Access Compliance Report

Public Rights-of-Way

(Curb Ramps)

Intersection ID: 14946	Main Street: DILWORTH_RD_WEST	Cross Street: E WORTHINGTON AV	Location: W
ADA ID: 0EC247F53CCB	Ramp Type: Perp	Initial Pass/Fail: Fail	Overall Compliance: No
Severity Score: 22.5			
Codes/Mitigation Info/Possible Solution		Field Measurements/Component Compliance

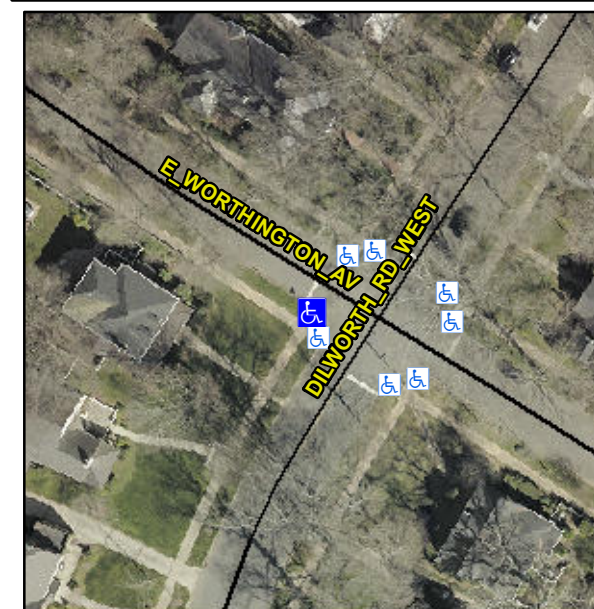
R304.5.1, R304.2.2, R304.5.3

Compliance	Description	Data	Compliance	Description	Data
N/A	Ramp Length (in)	58.0	No	Ramp Slope (%)	8.7
No	Ramp Width (in)	46.0	No	Ramp XSlope (%)	3.4
N/A	Flare Type LT	N/A	N/A	Flare Type RT	N/A
N/A	Flare Slope LT (%)	N/A	N/A	Flare Slope RT (%)	N/A
N/A	Flare Traversable LT?	N/A	N/A	Flare Traversable RT?	N/A
N/A	Landing Length (in)	N/A	N/A	DWS Provided?	N/A
N/A	Landing Width (in)	N/A	N/A	DWS Contrast?	N/A
N/A	Landing Slope (%)	N/A	N/A	DWS Length (in)	N/A
N/A	Landing X Slope (%)	N/A	N/A	DWS Full Width?	N/A
N/A	Landing Curb? (Y/N)	N/A	N/A	DWS Offset (in)	N/A
N/A	Shared Landing?	N/A			
N/A	Gutter Ponding?	N/A	N/A	Gutter Slope (%)	N/A
N/A	Gutter Lip Ht (in)	N/A	N/A	Gutter X Slope (%)	N/A
N/A	Painted X Walk1?	No	N/A	Painted X Walk2?	N/A
	X Walk 1 Direction	To NE		X Walk 2 Direction	N/A
N/A	X Walk 1 Width (in)	N/A	N/A	X Walk 2 Width (in)	N/A
	X Walk 1 Slope (%)	4.1		X Walk 2 Slope (%)	N/A
	X Walk 1 X Slope (%)	1.9		X Walk 2 X Slope (%)	N/A

Remove & Replace Entire Ramp.
